**Town of Rotterdam
Planning Commission
September 5, 2023**

- 2. DAIM Logistics (Contract Vendee) – 681 Mariaville Road.** Preliminary Site Plan review to construct a ±120,000 square foot warehouse building on an existing ±11.1-acre parcel. Engineer: Empire Engineering, PLLC.

Re: *DAIM Logistics - Site Plan Application - Proposed Warehouse / Office*
681 Mariaville Road, Town of Rotterdam
CTMA Project No. 22.2224

SITE LAYOUT PLAN
NO. 20240223
Scale: 1"=50'
23006
Sheet 1/19

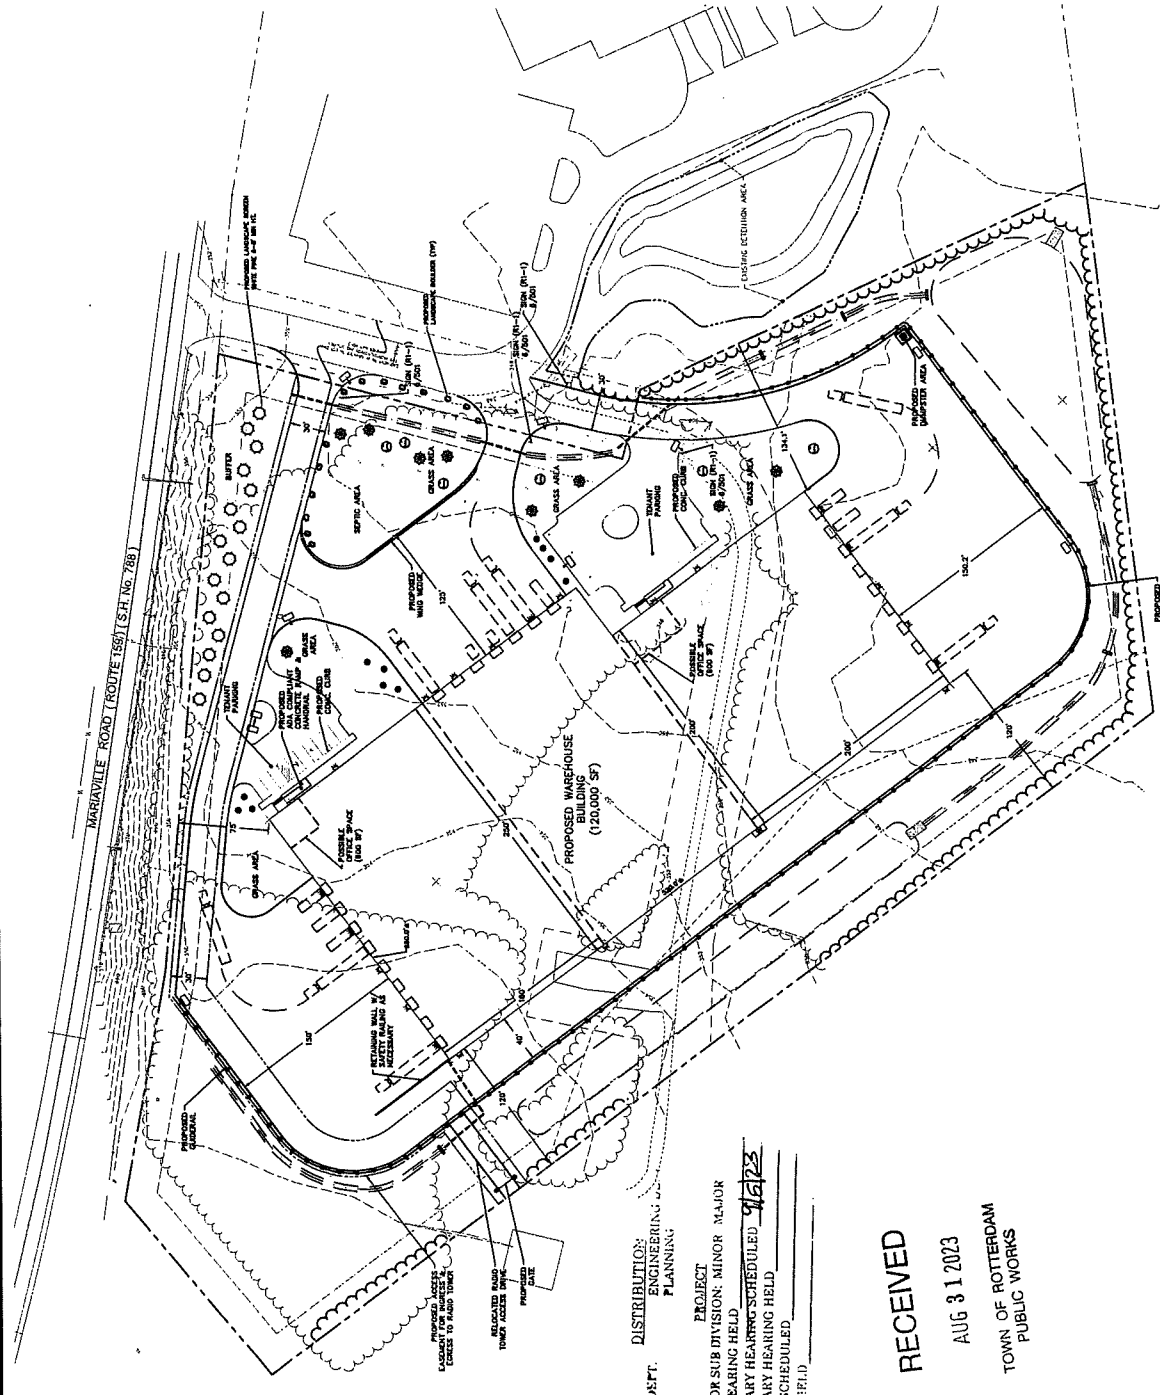
3. We offer the comments regarding Sheet C101 - Site Layout Plan:
 - a. Previous Comment - The design shows a proposed three-legged intersection with the existing TFP driveway that may need reconfiguration to minimize conflicts and maximize safety of the intersection. *New Comment - Stops signs have been added to the plans and the applicants engineer has indicated that traffic volumes and vehicles speeds will be low. The Planning Commission should determine if anything additional is needed for this condition.*

GRADING PLAN
NO. 192023
DATE 11/19/2023
SCALE 1"=50'
SHEET 23/29

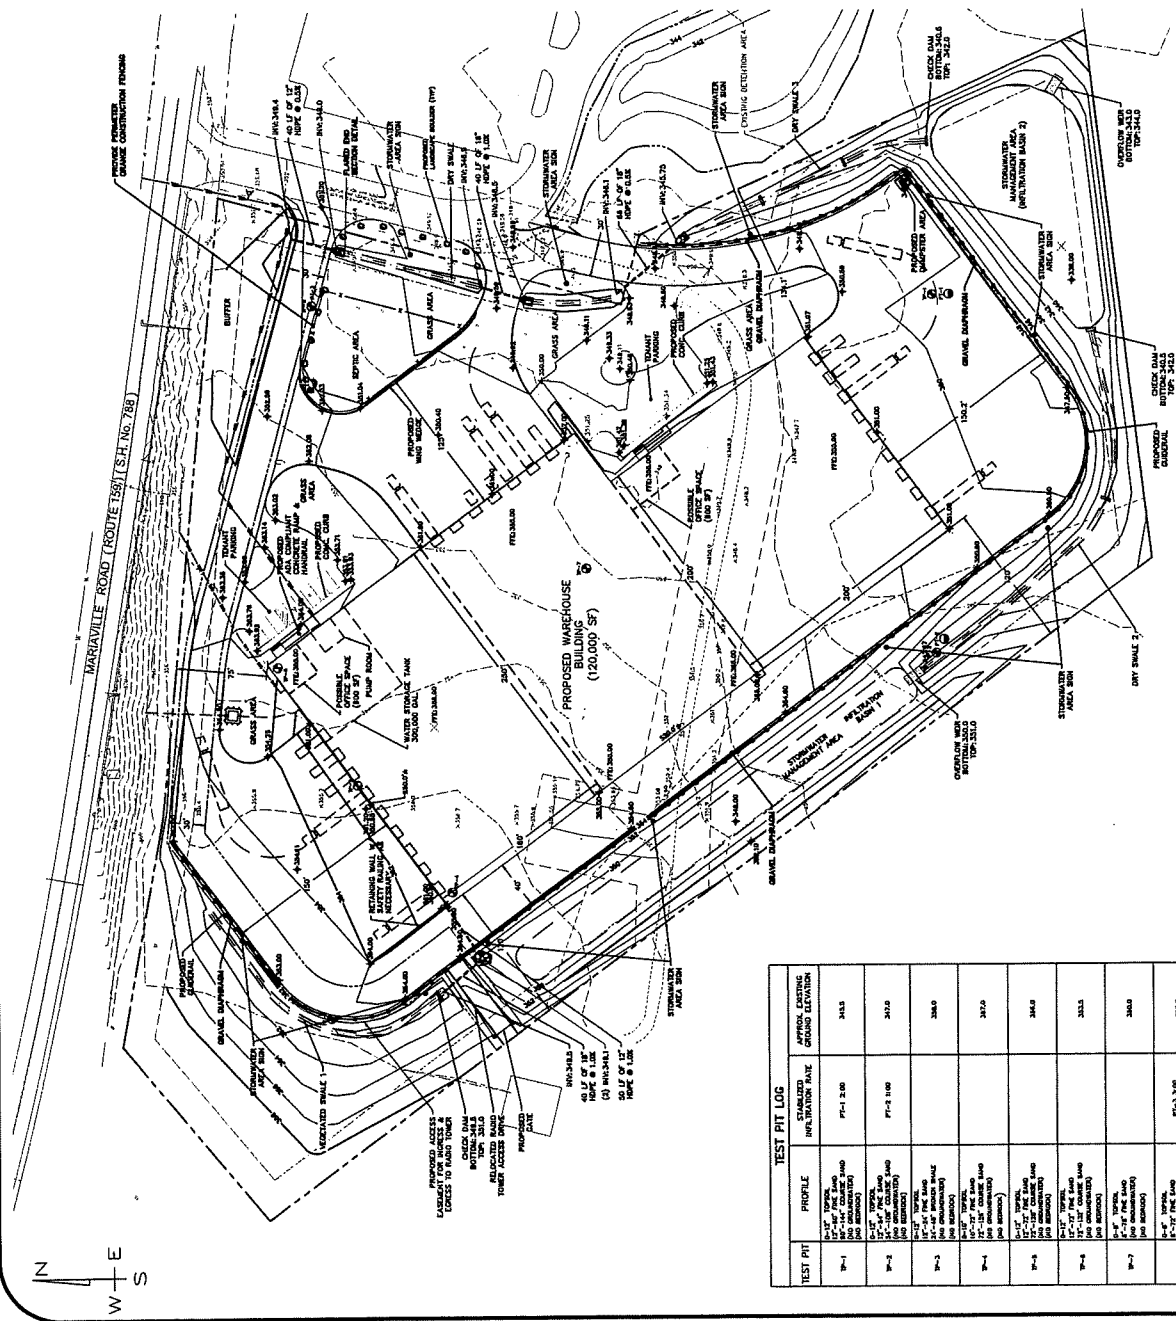
4. We offer the comments regarding Sheet C102 - Grading Plan:
 - a. Previous Comment - The south tenant parking area shows spot grades at 3.5'± below the first-floor elevation without any stairs or ramps shown from the building to the sidewalk. Please clarify how the access to the building will work in this area. *New Comment - A ramp has been added in this area but appears to not be long enough to provide an accessible path to the building. The applicant shall document that the proposed design will provide an accessible path to the building.*

- b. Previous Comment - Consideration should be given to providing an oil/water separator between the drain at the north loading dock area Infiltration Basin 1 as this area would have trucks sitting for periods of time. *New Comment - the response indicated that this is not a hotspot and does not require an oil water separator, but it does require pretreatment per the NYS Stormwater Management Design Manual. The stormwater from this area will drain directly into the infiltration practice without any pretreatment. See comment 7.a. below on pretreatment requirements.*

- c. Previous Comment - The grading at the south end of Infiltration Basin 1 at Dry Swale 2 does not show a berm or elevation and contours of the basin bottom. Please review the grading in this area. *The plans do not appear to clarify the grading in this area.*

Scale	1"=60'	C104	Sheet 4 / 9
Job	23006

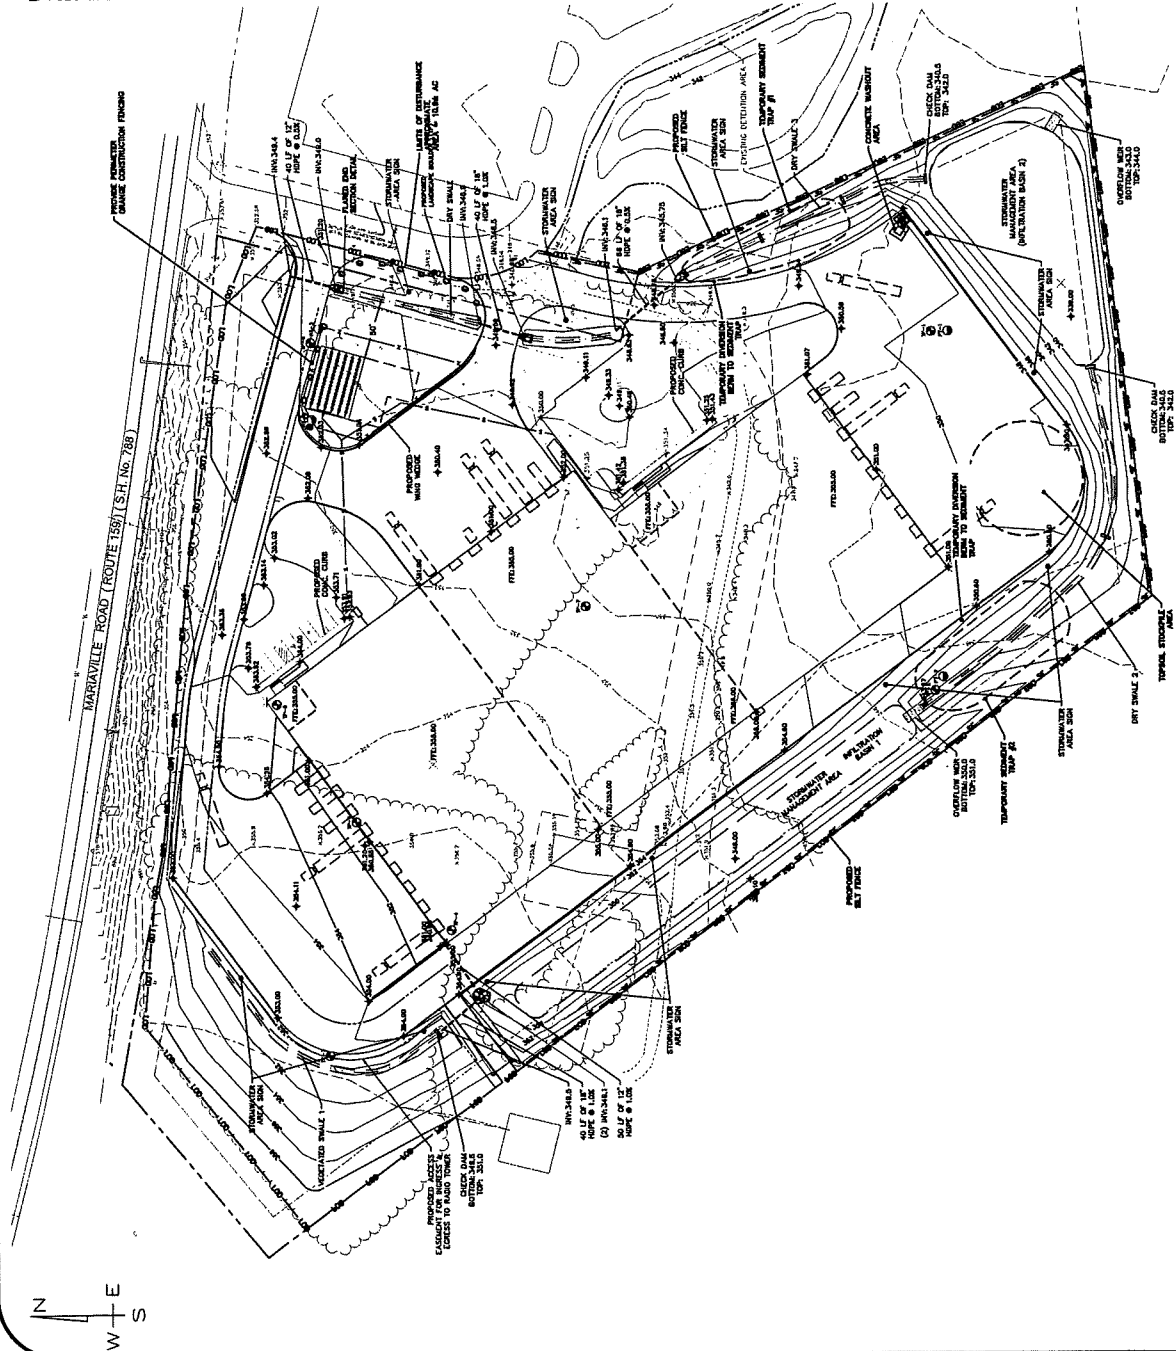
5. We offer the following comments regarding Sheet C104 - Erosion & Sediment Control Plan:
- a. Previous Comment - Construction phasing, sequencing, notes should be identified and listed on the plan. *New Comment - At a minimum a phasing plan and construction sequencing notes should be added to the plans.*
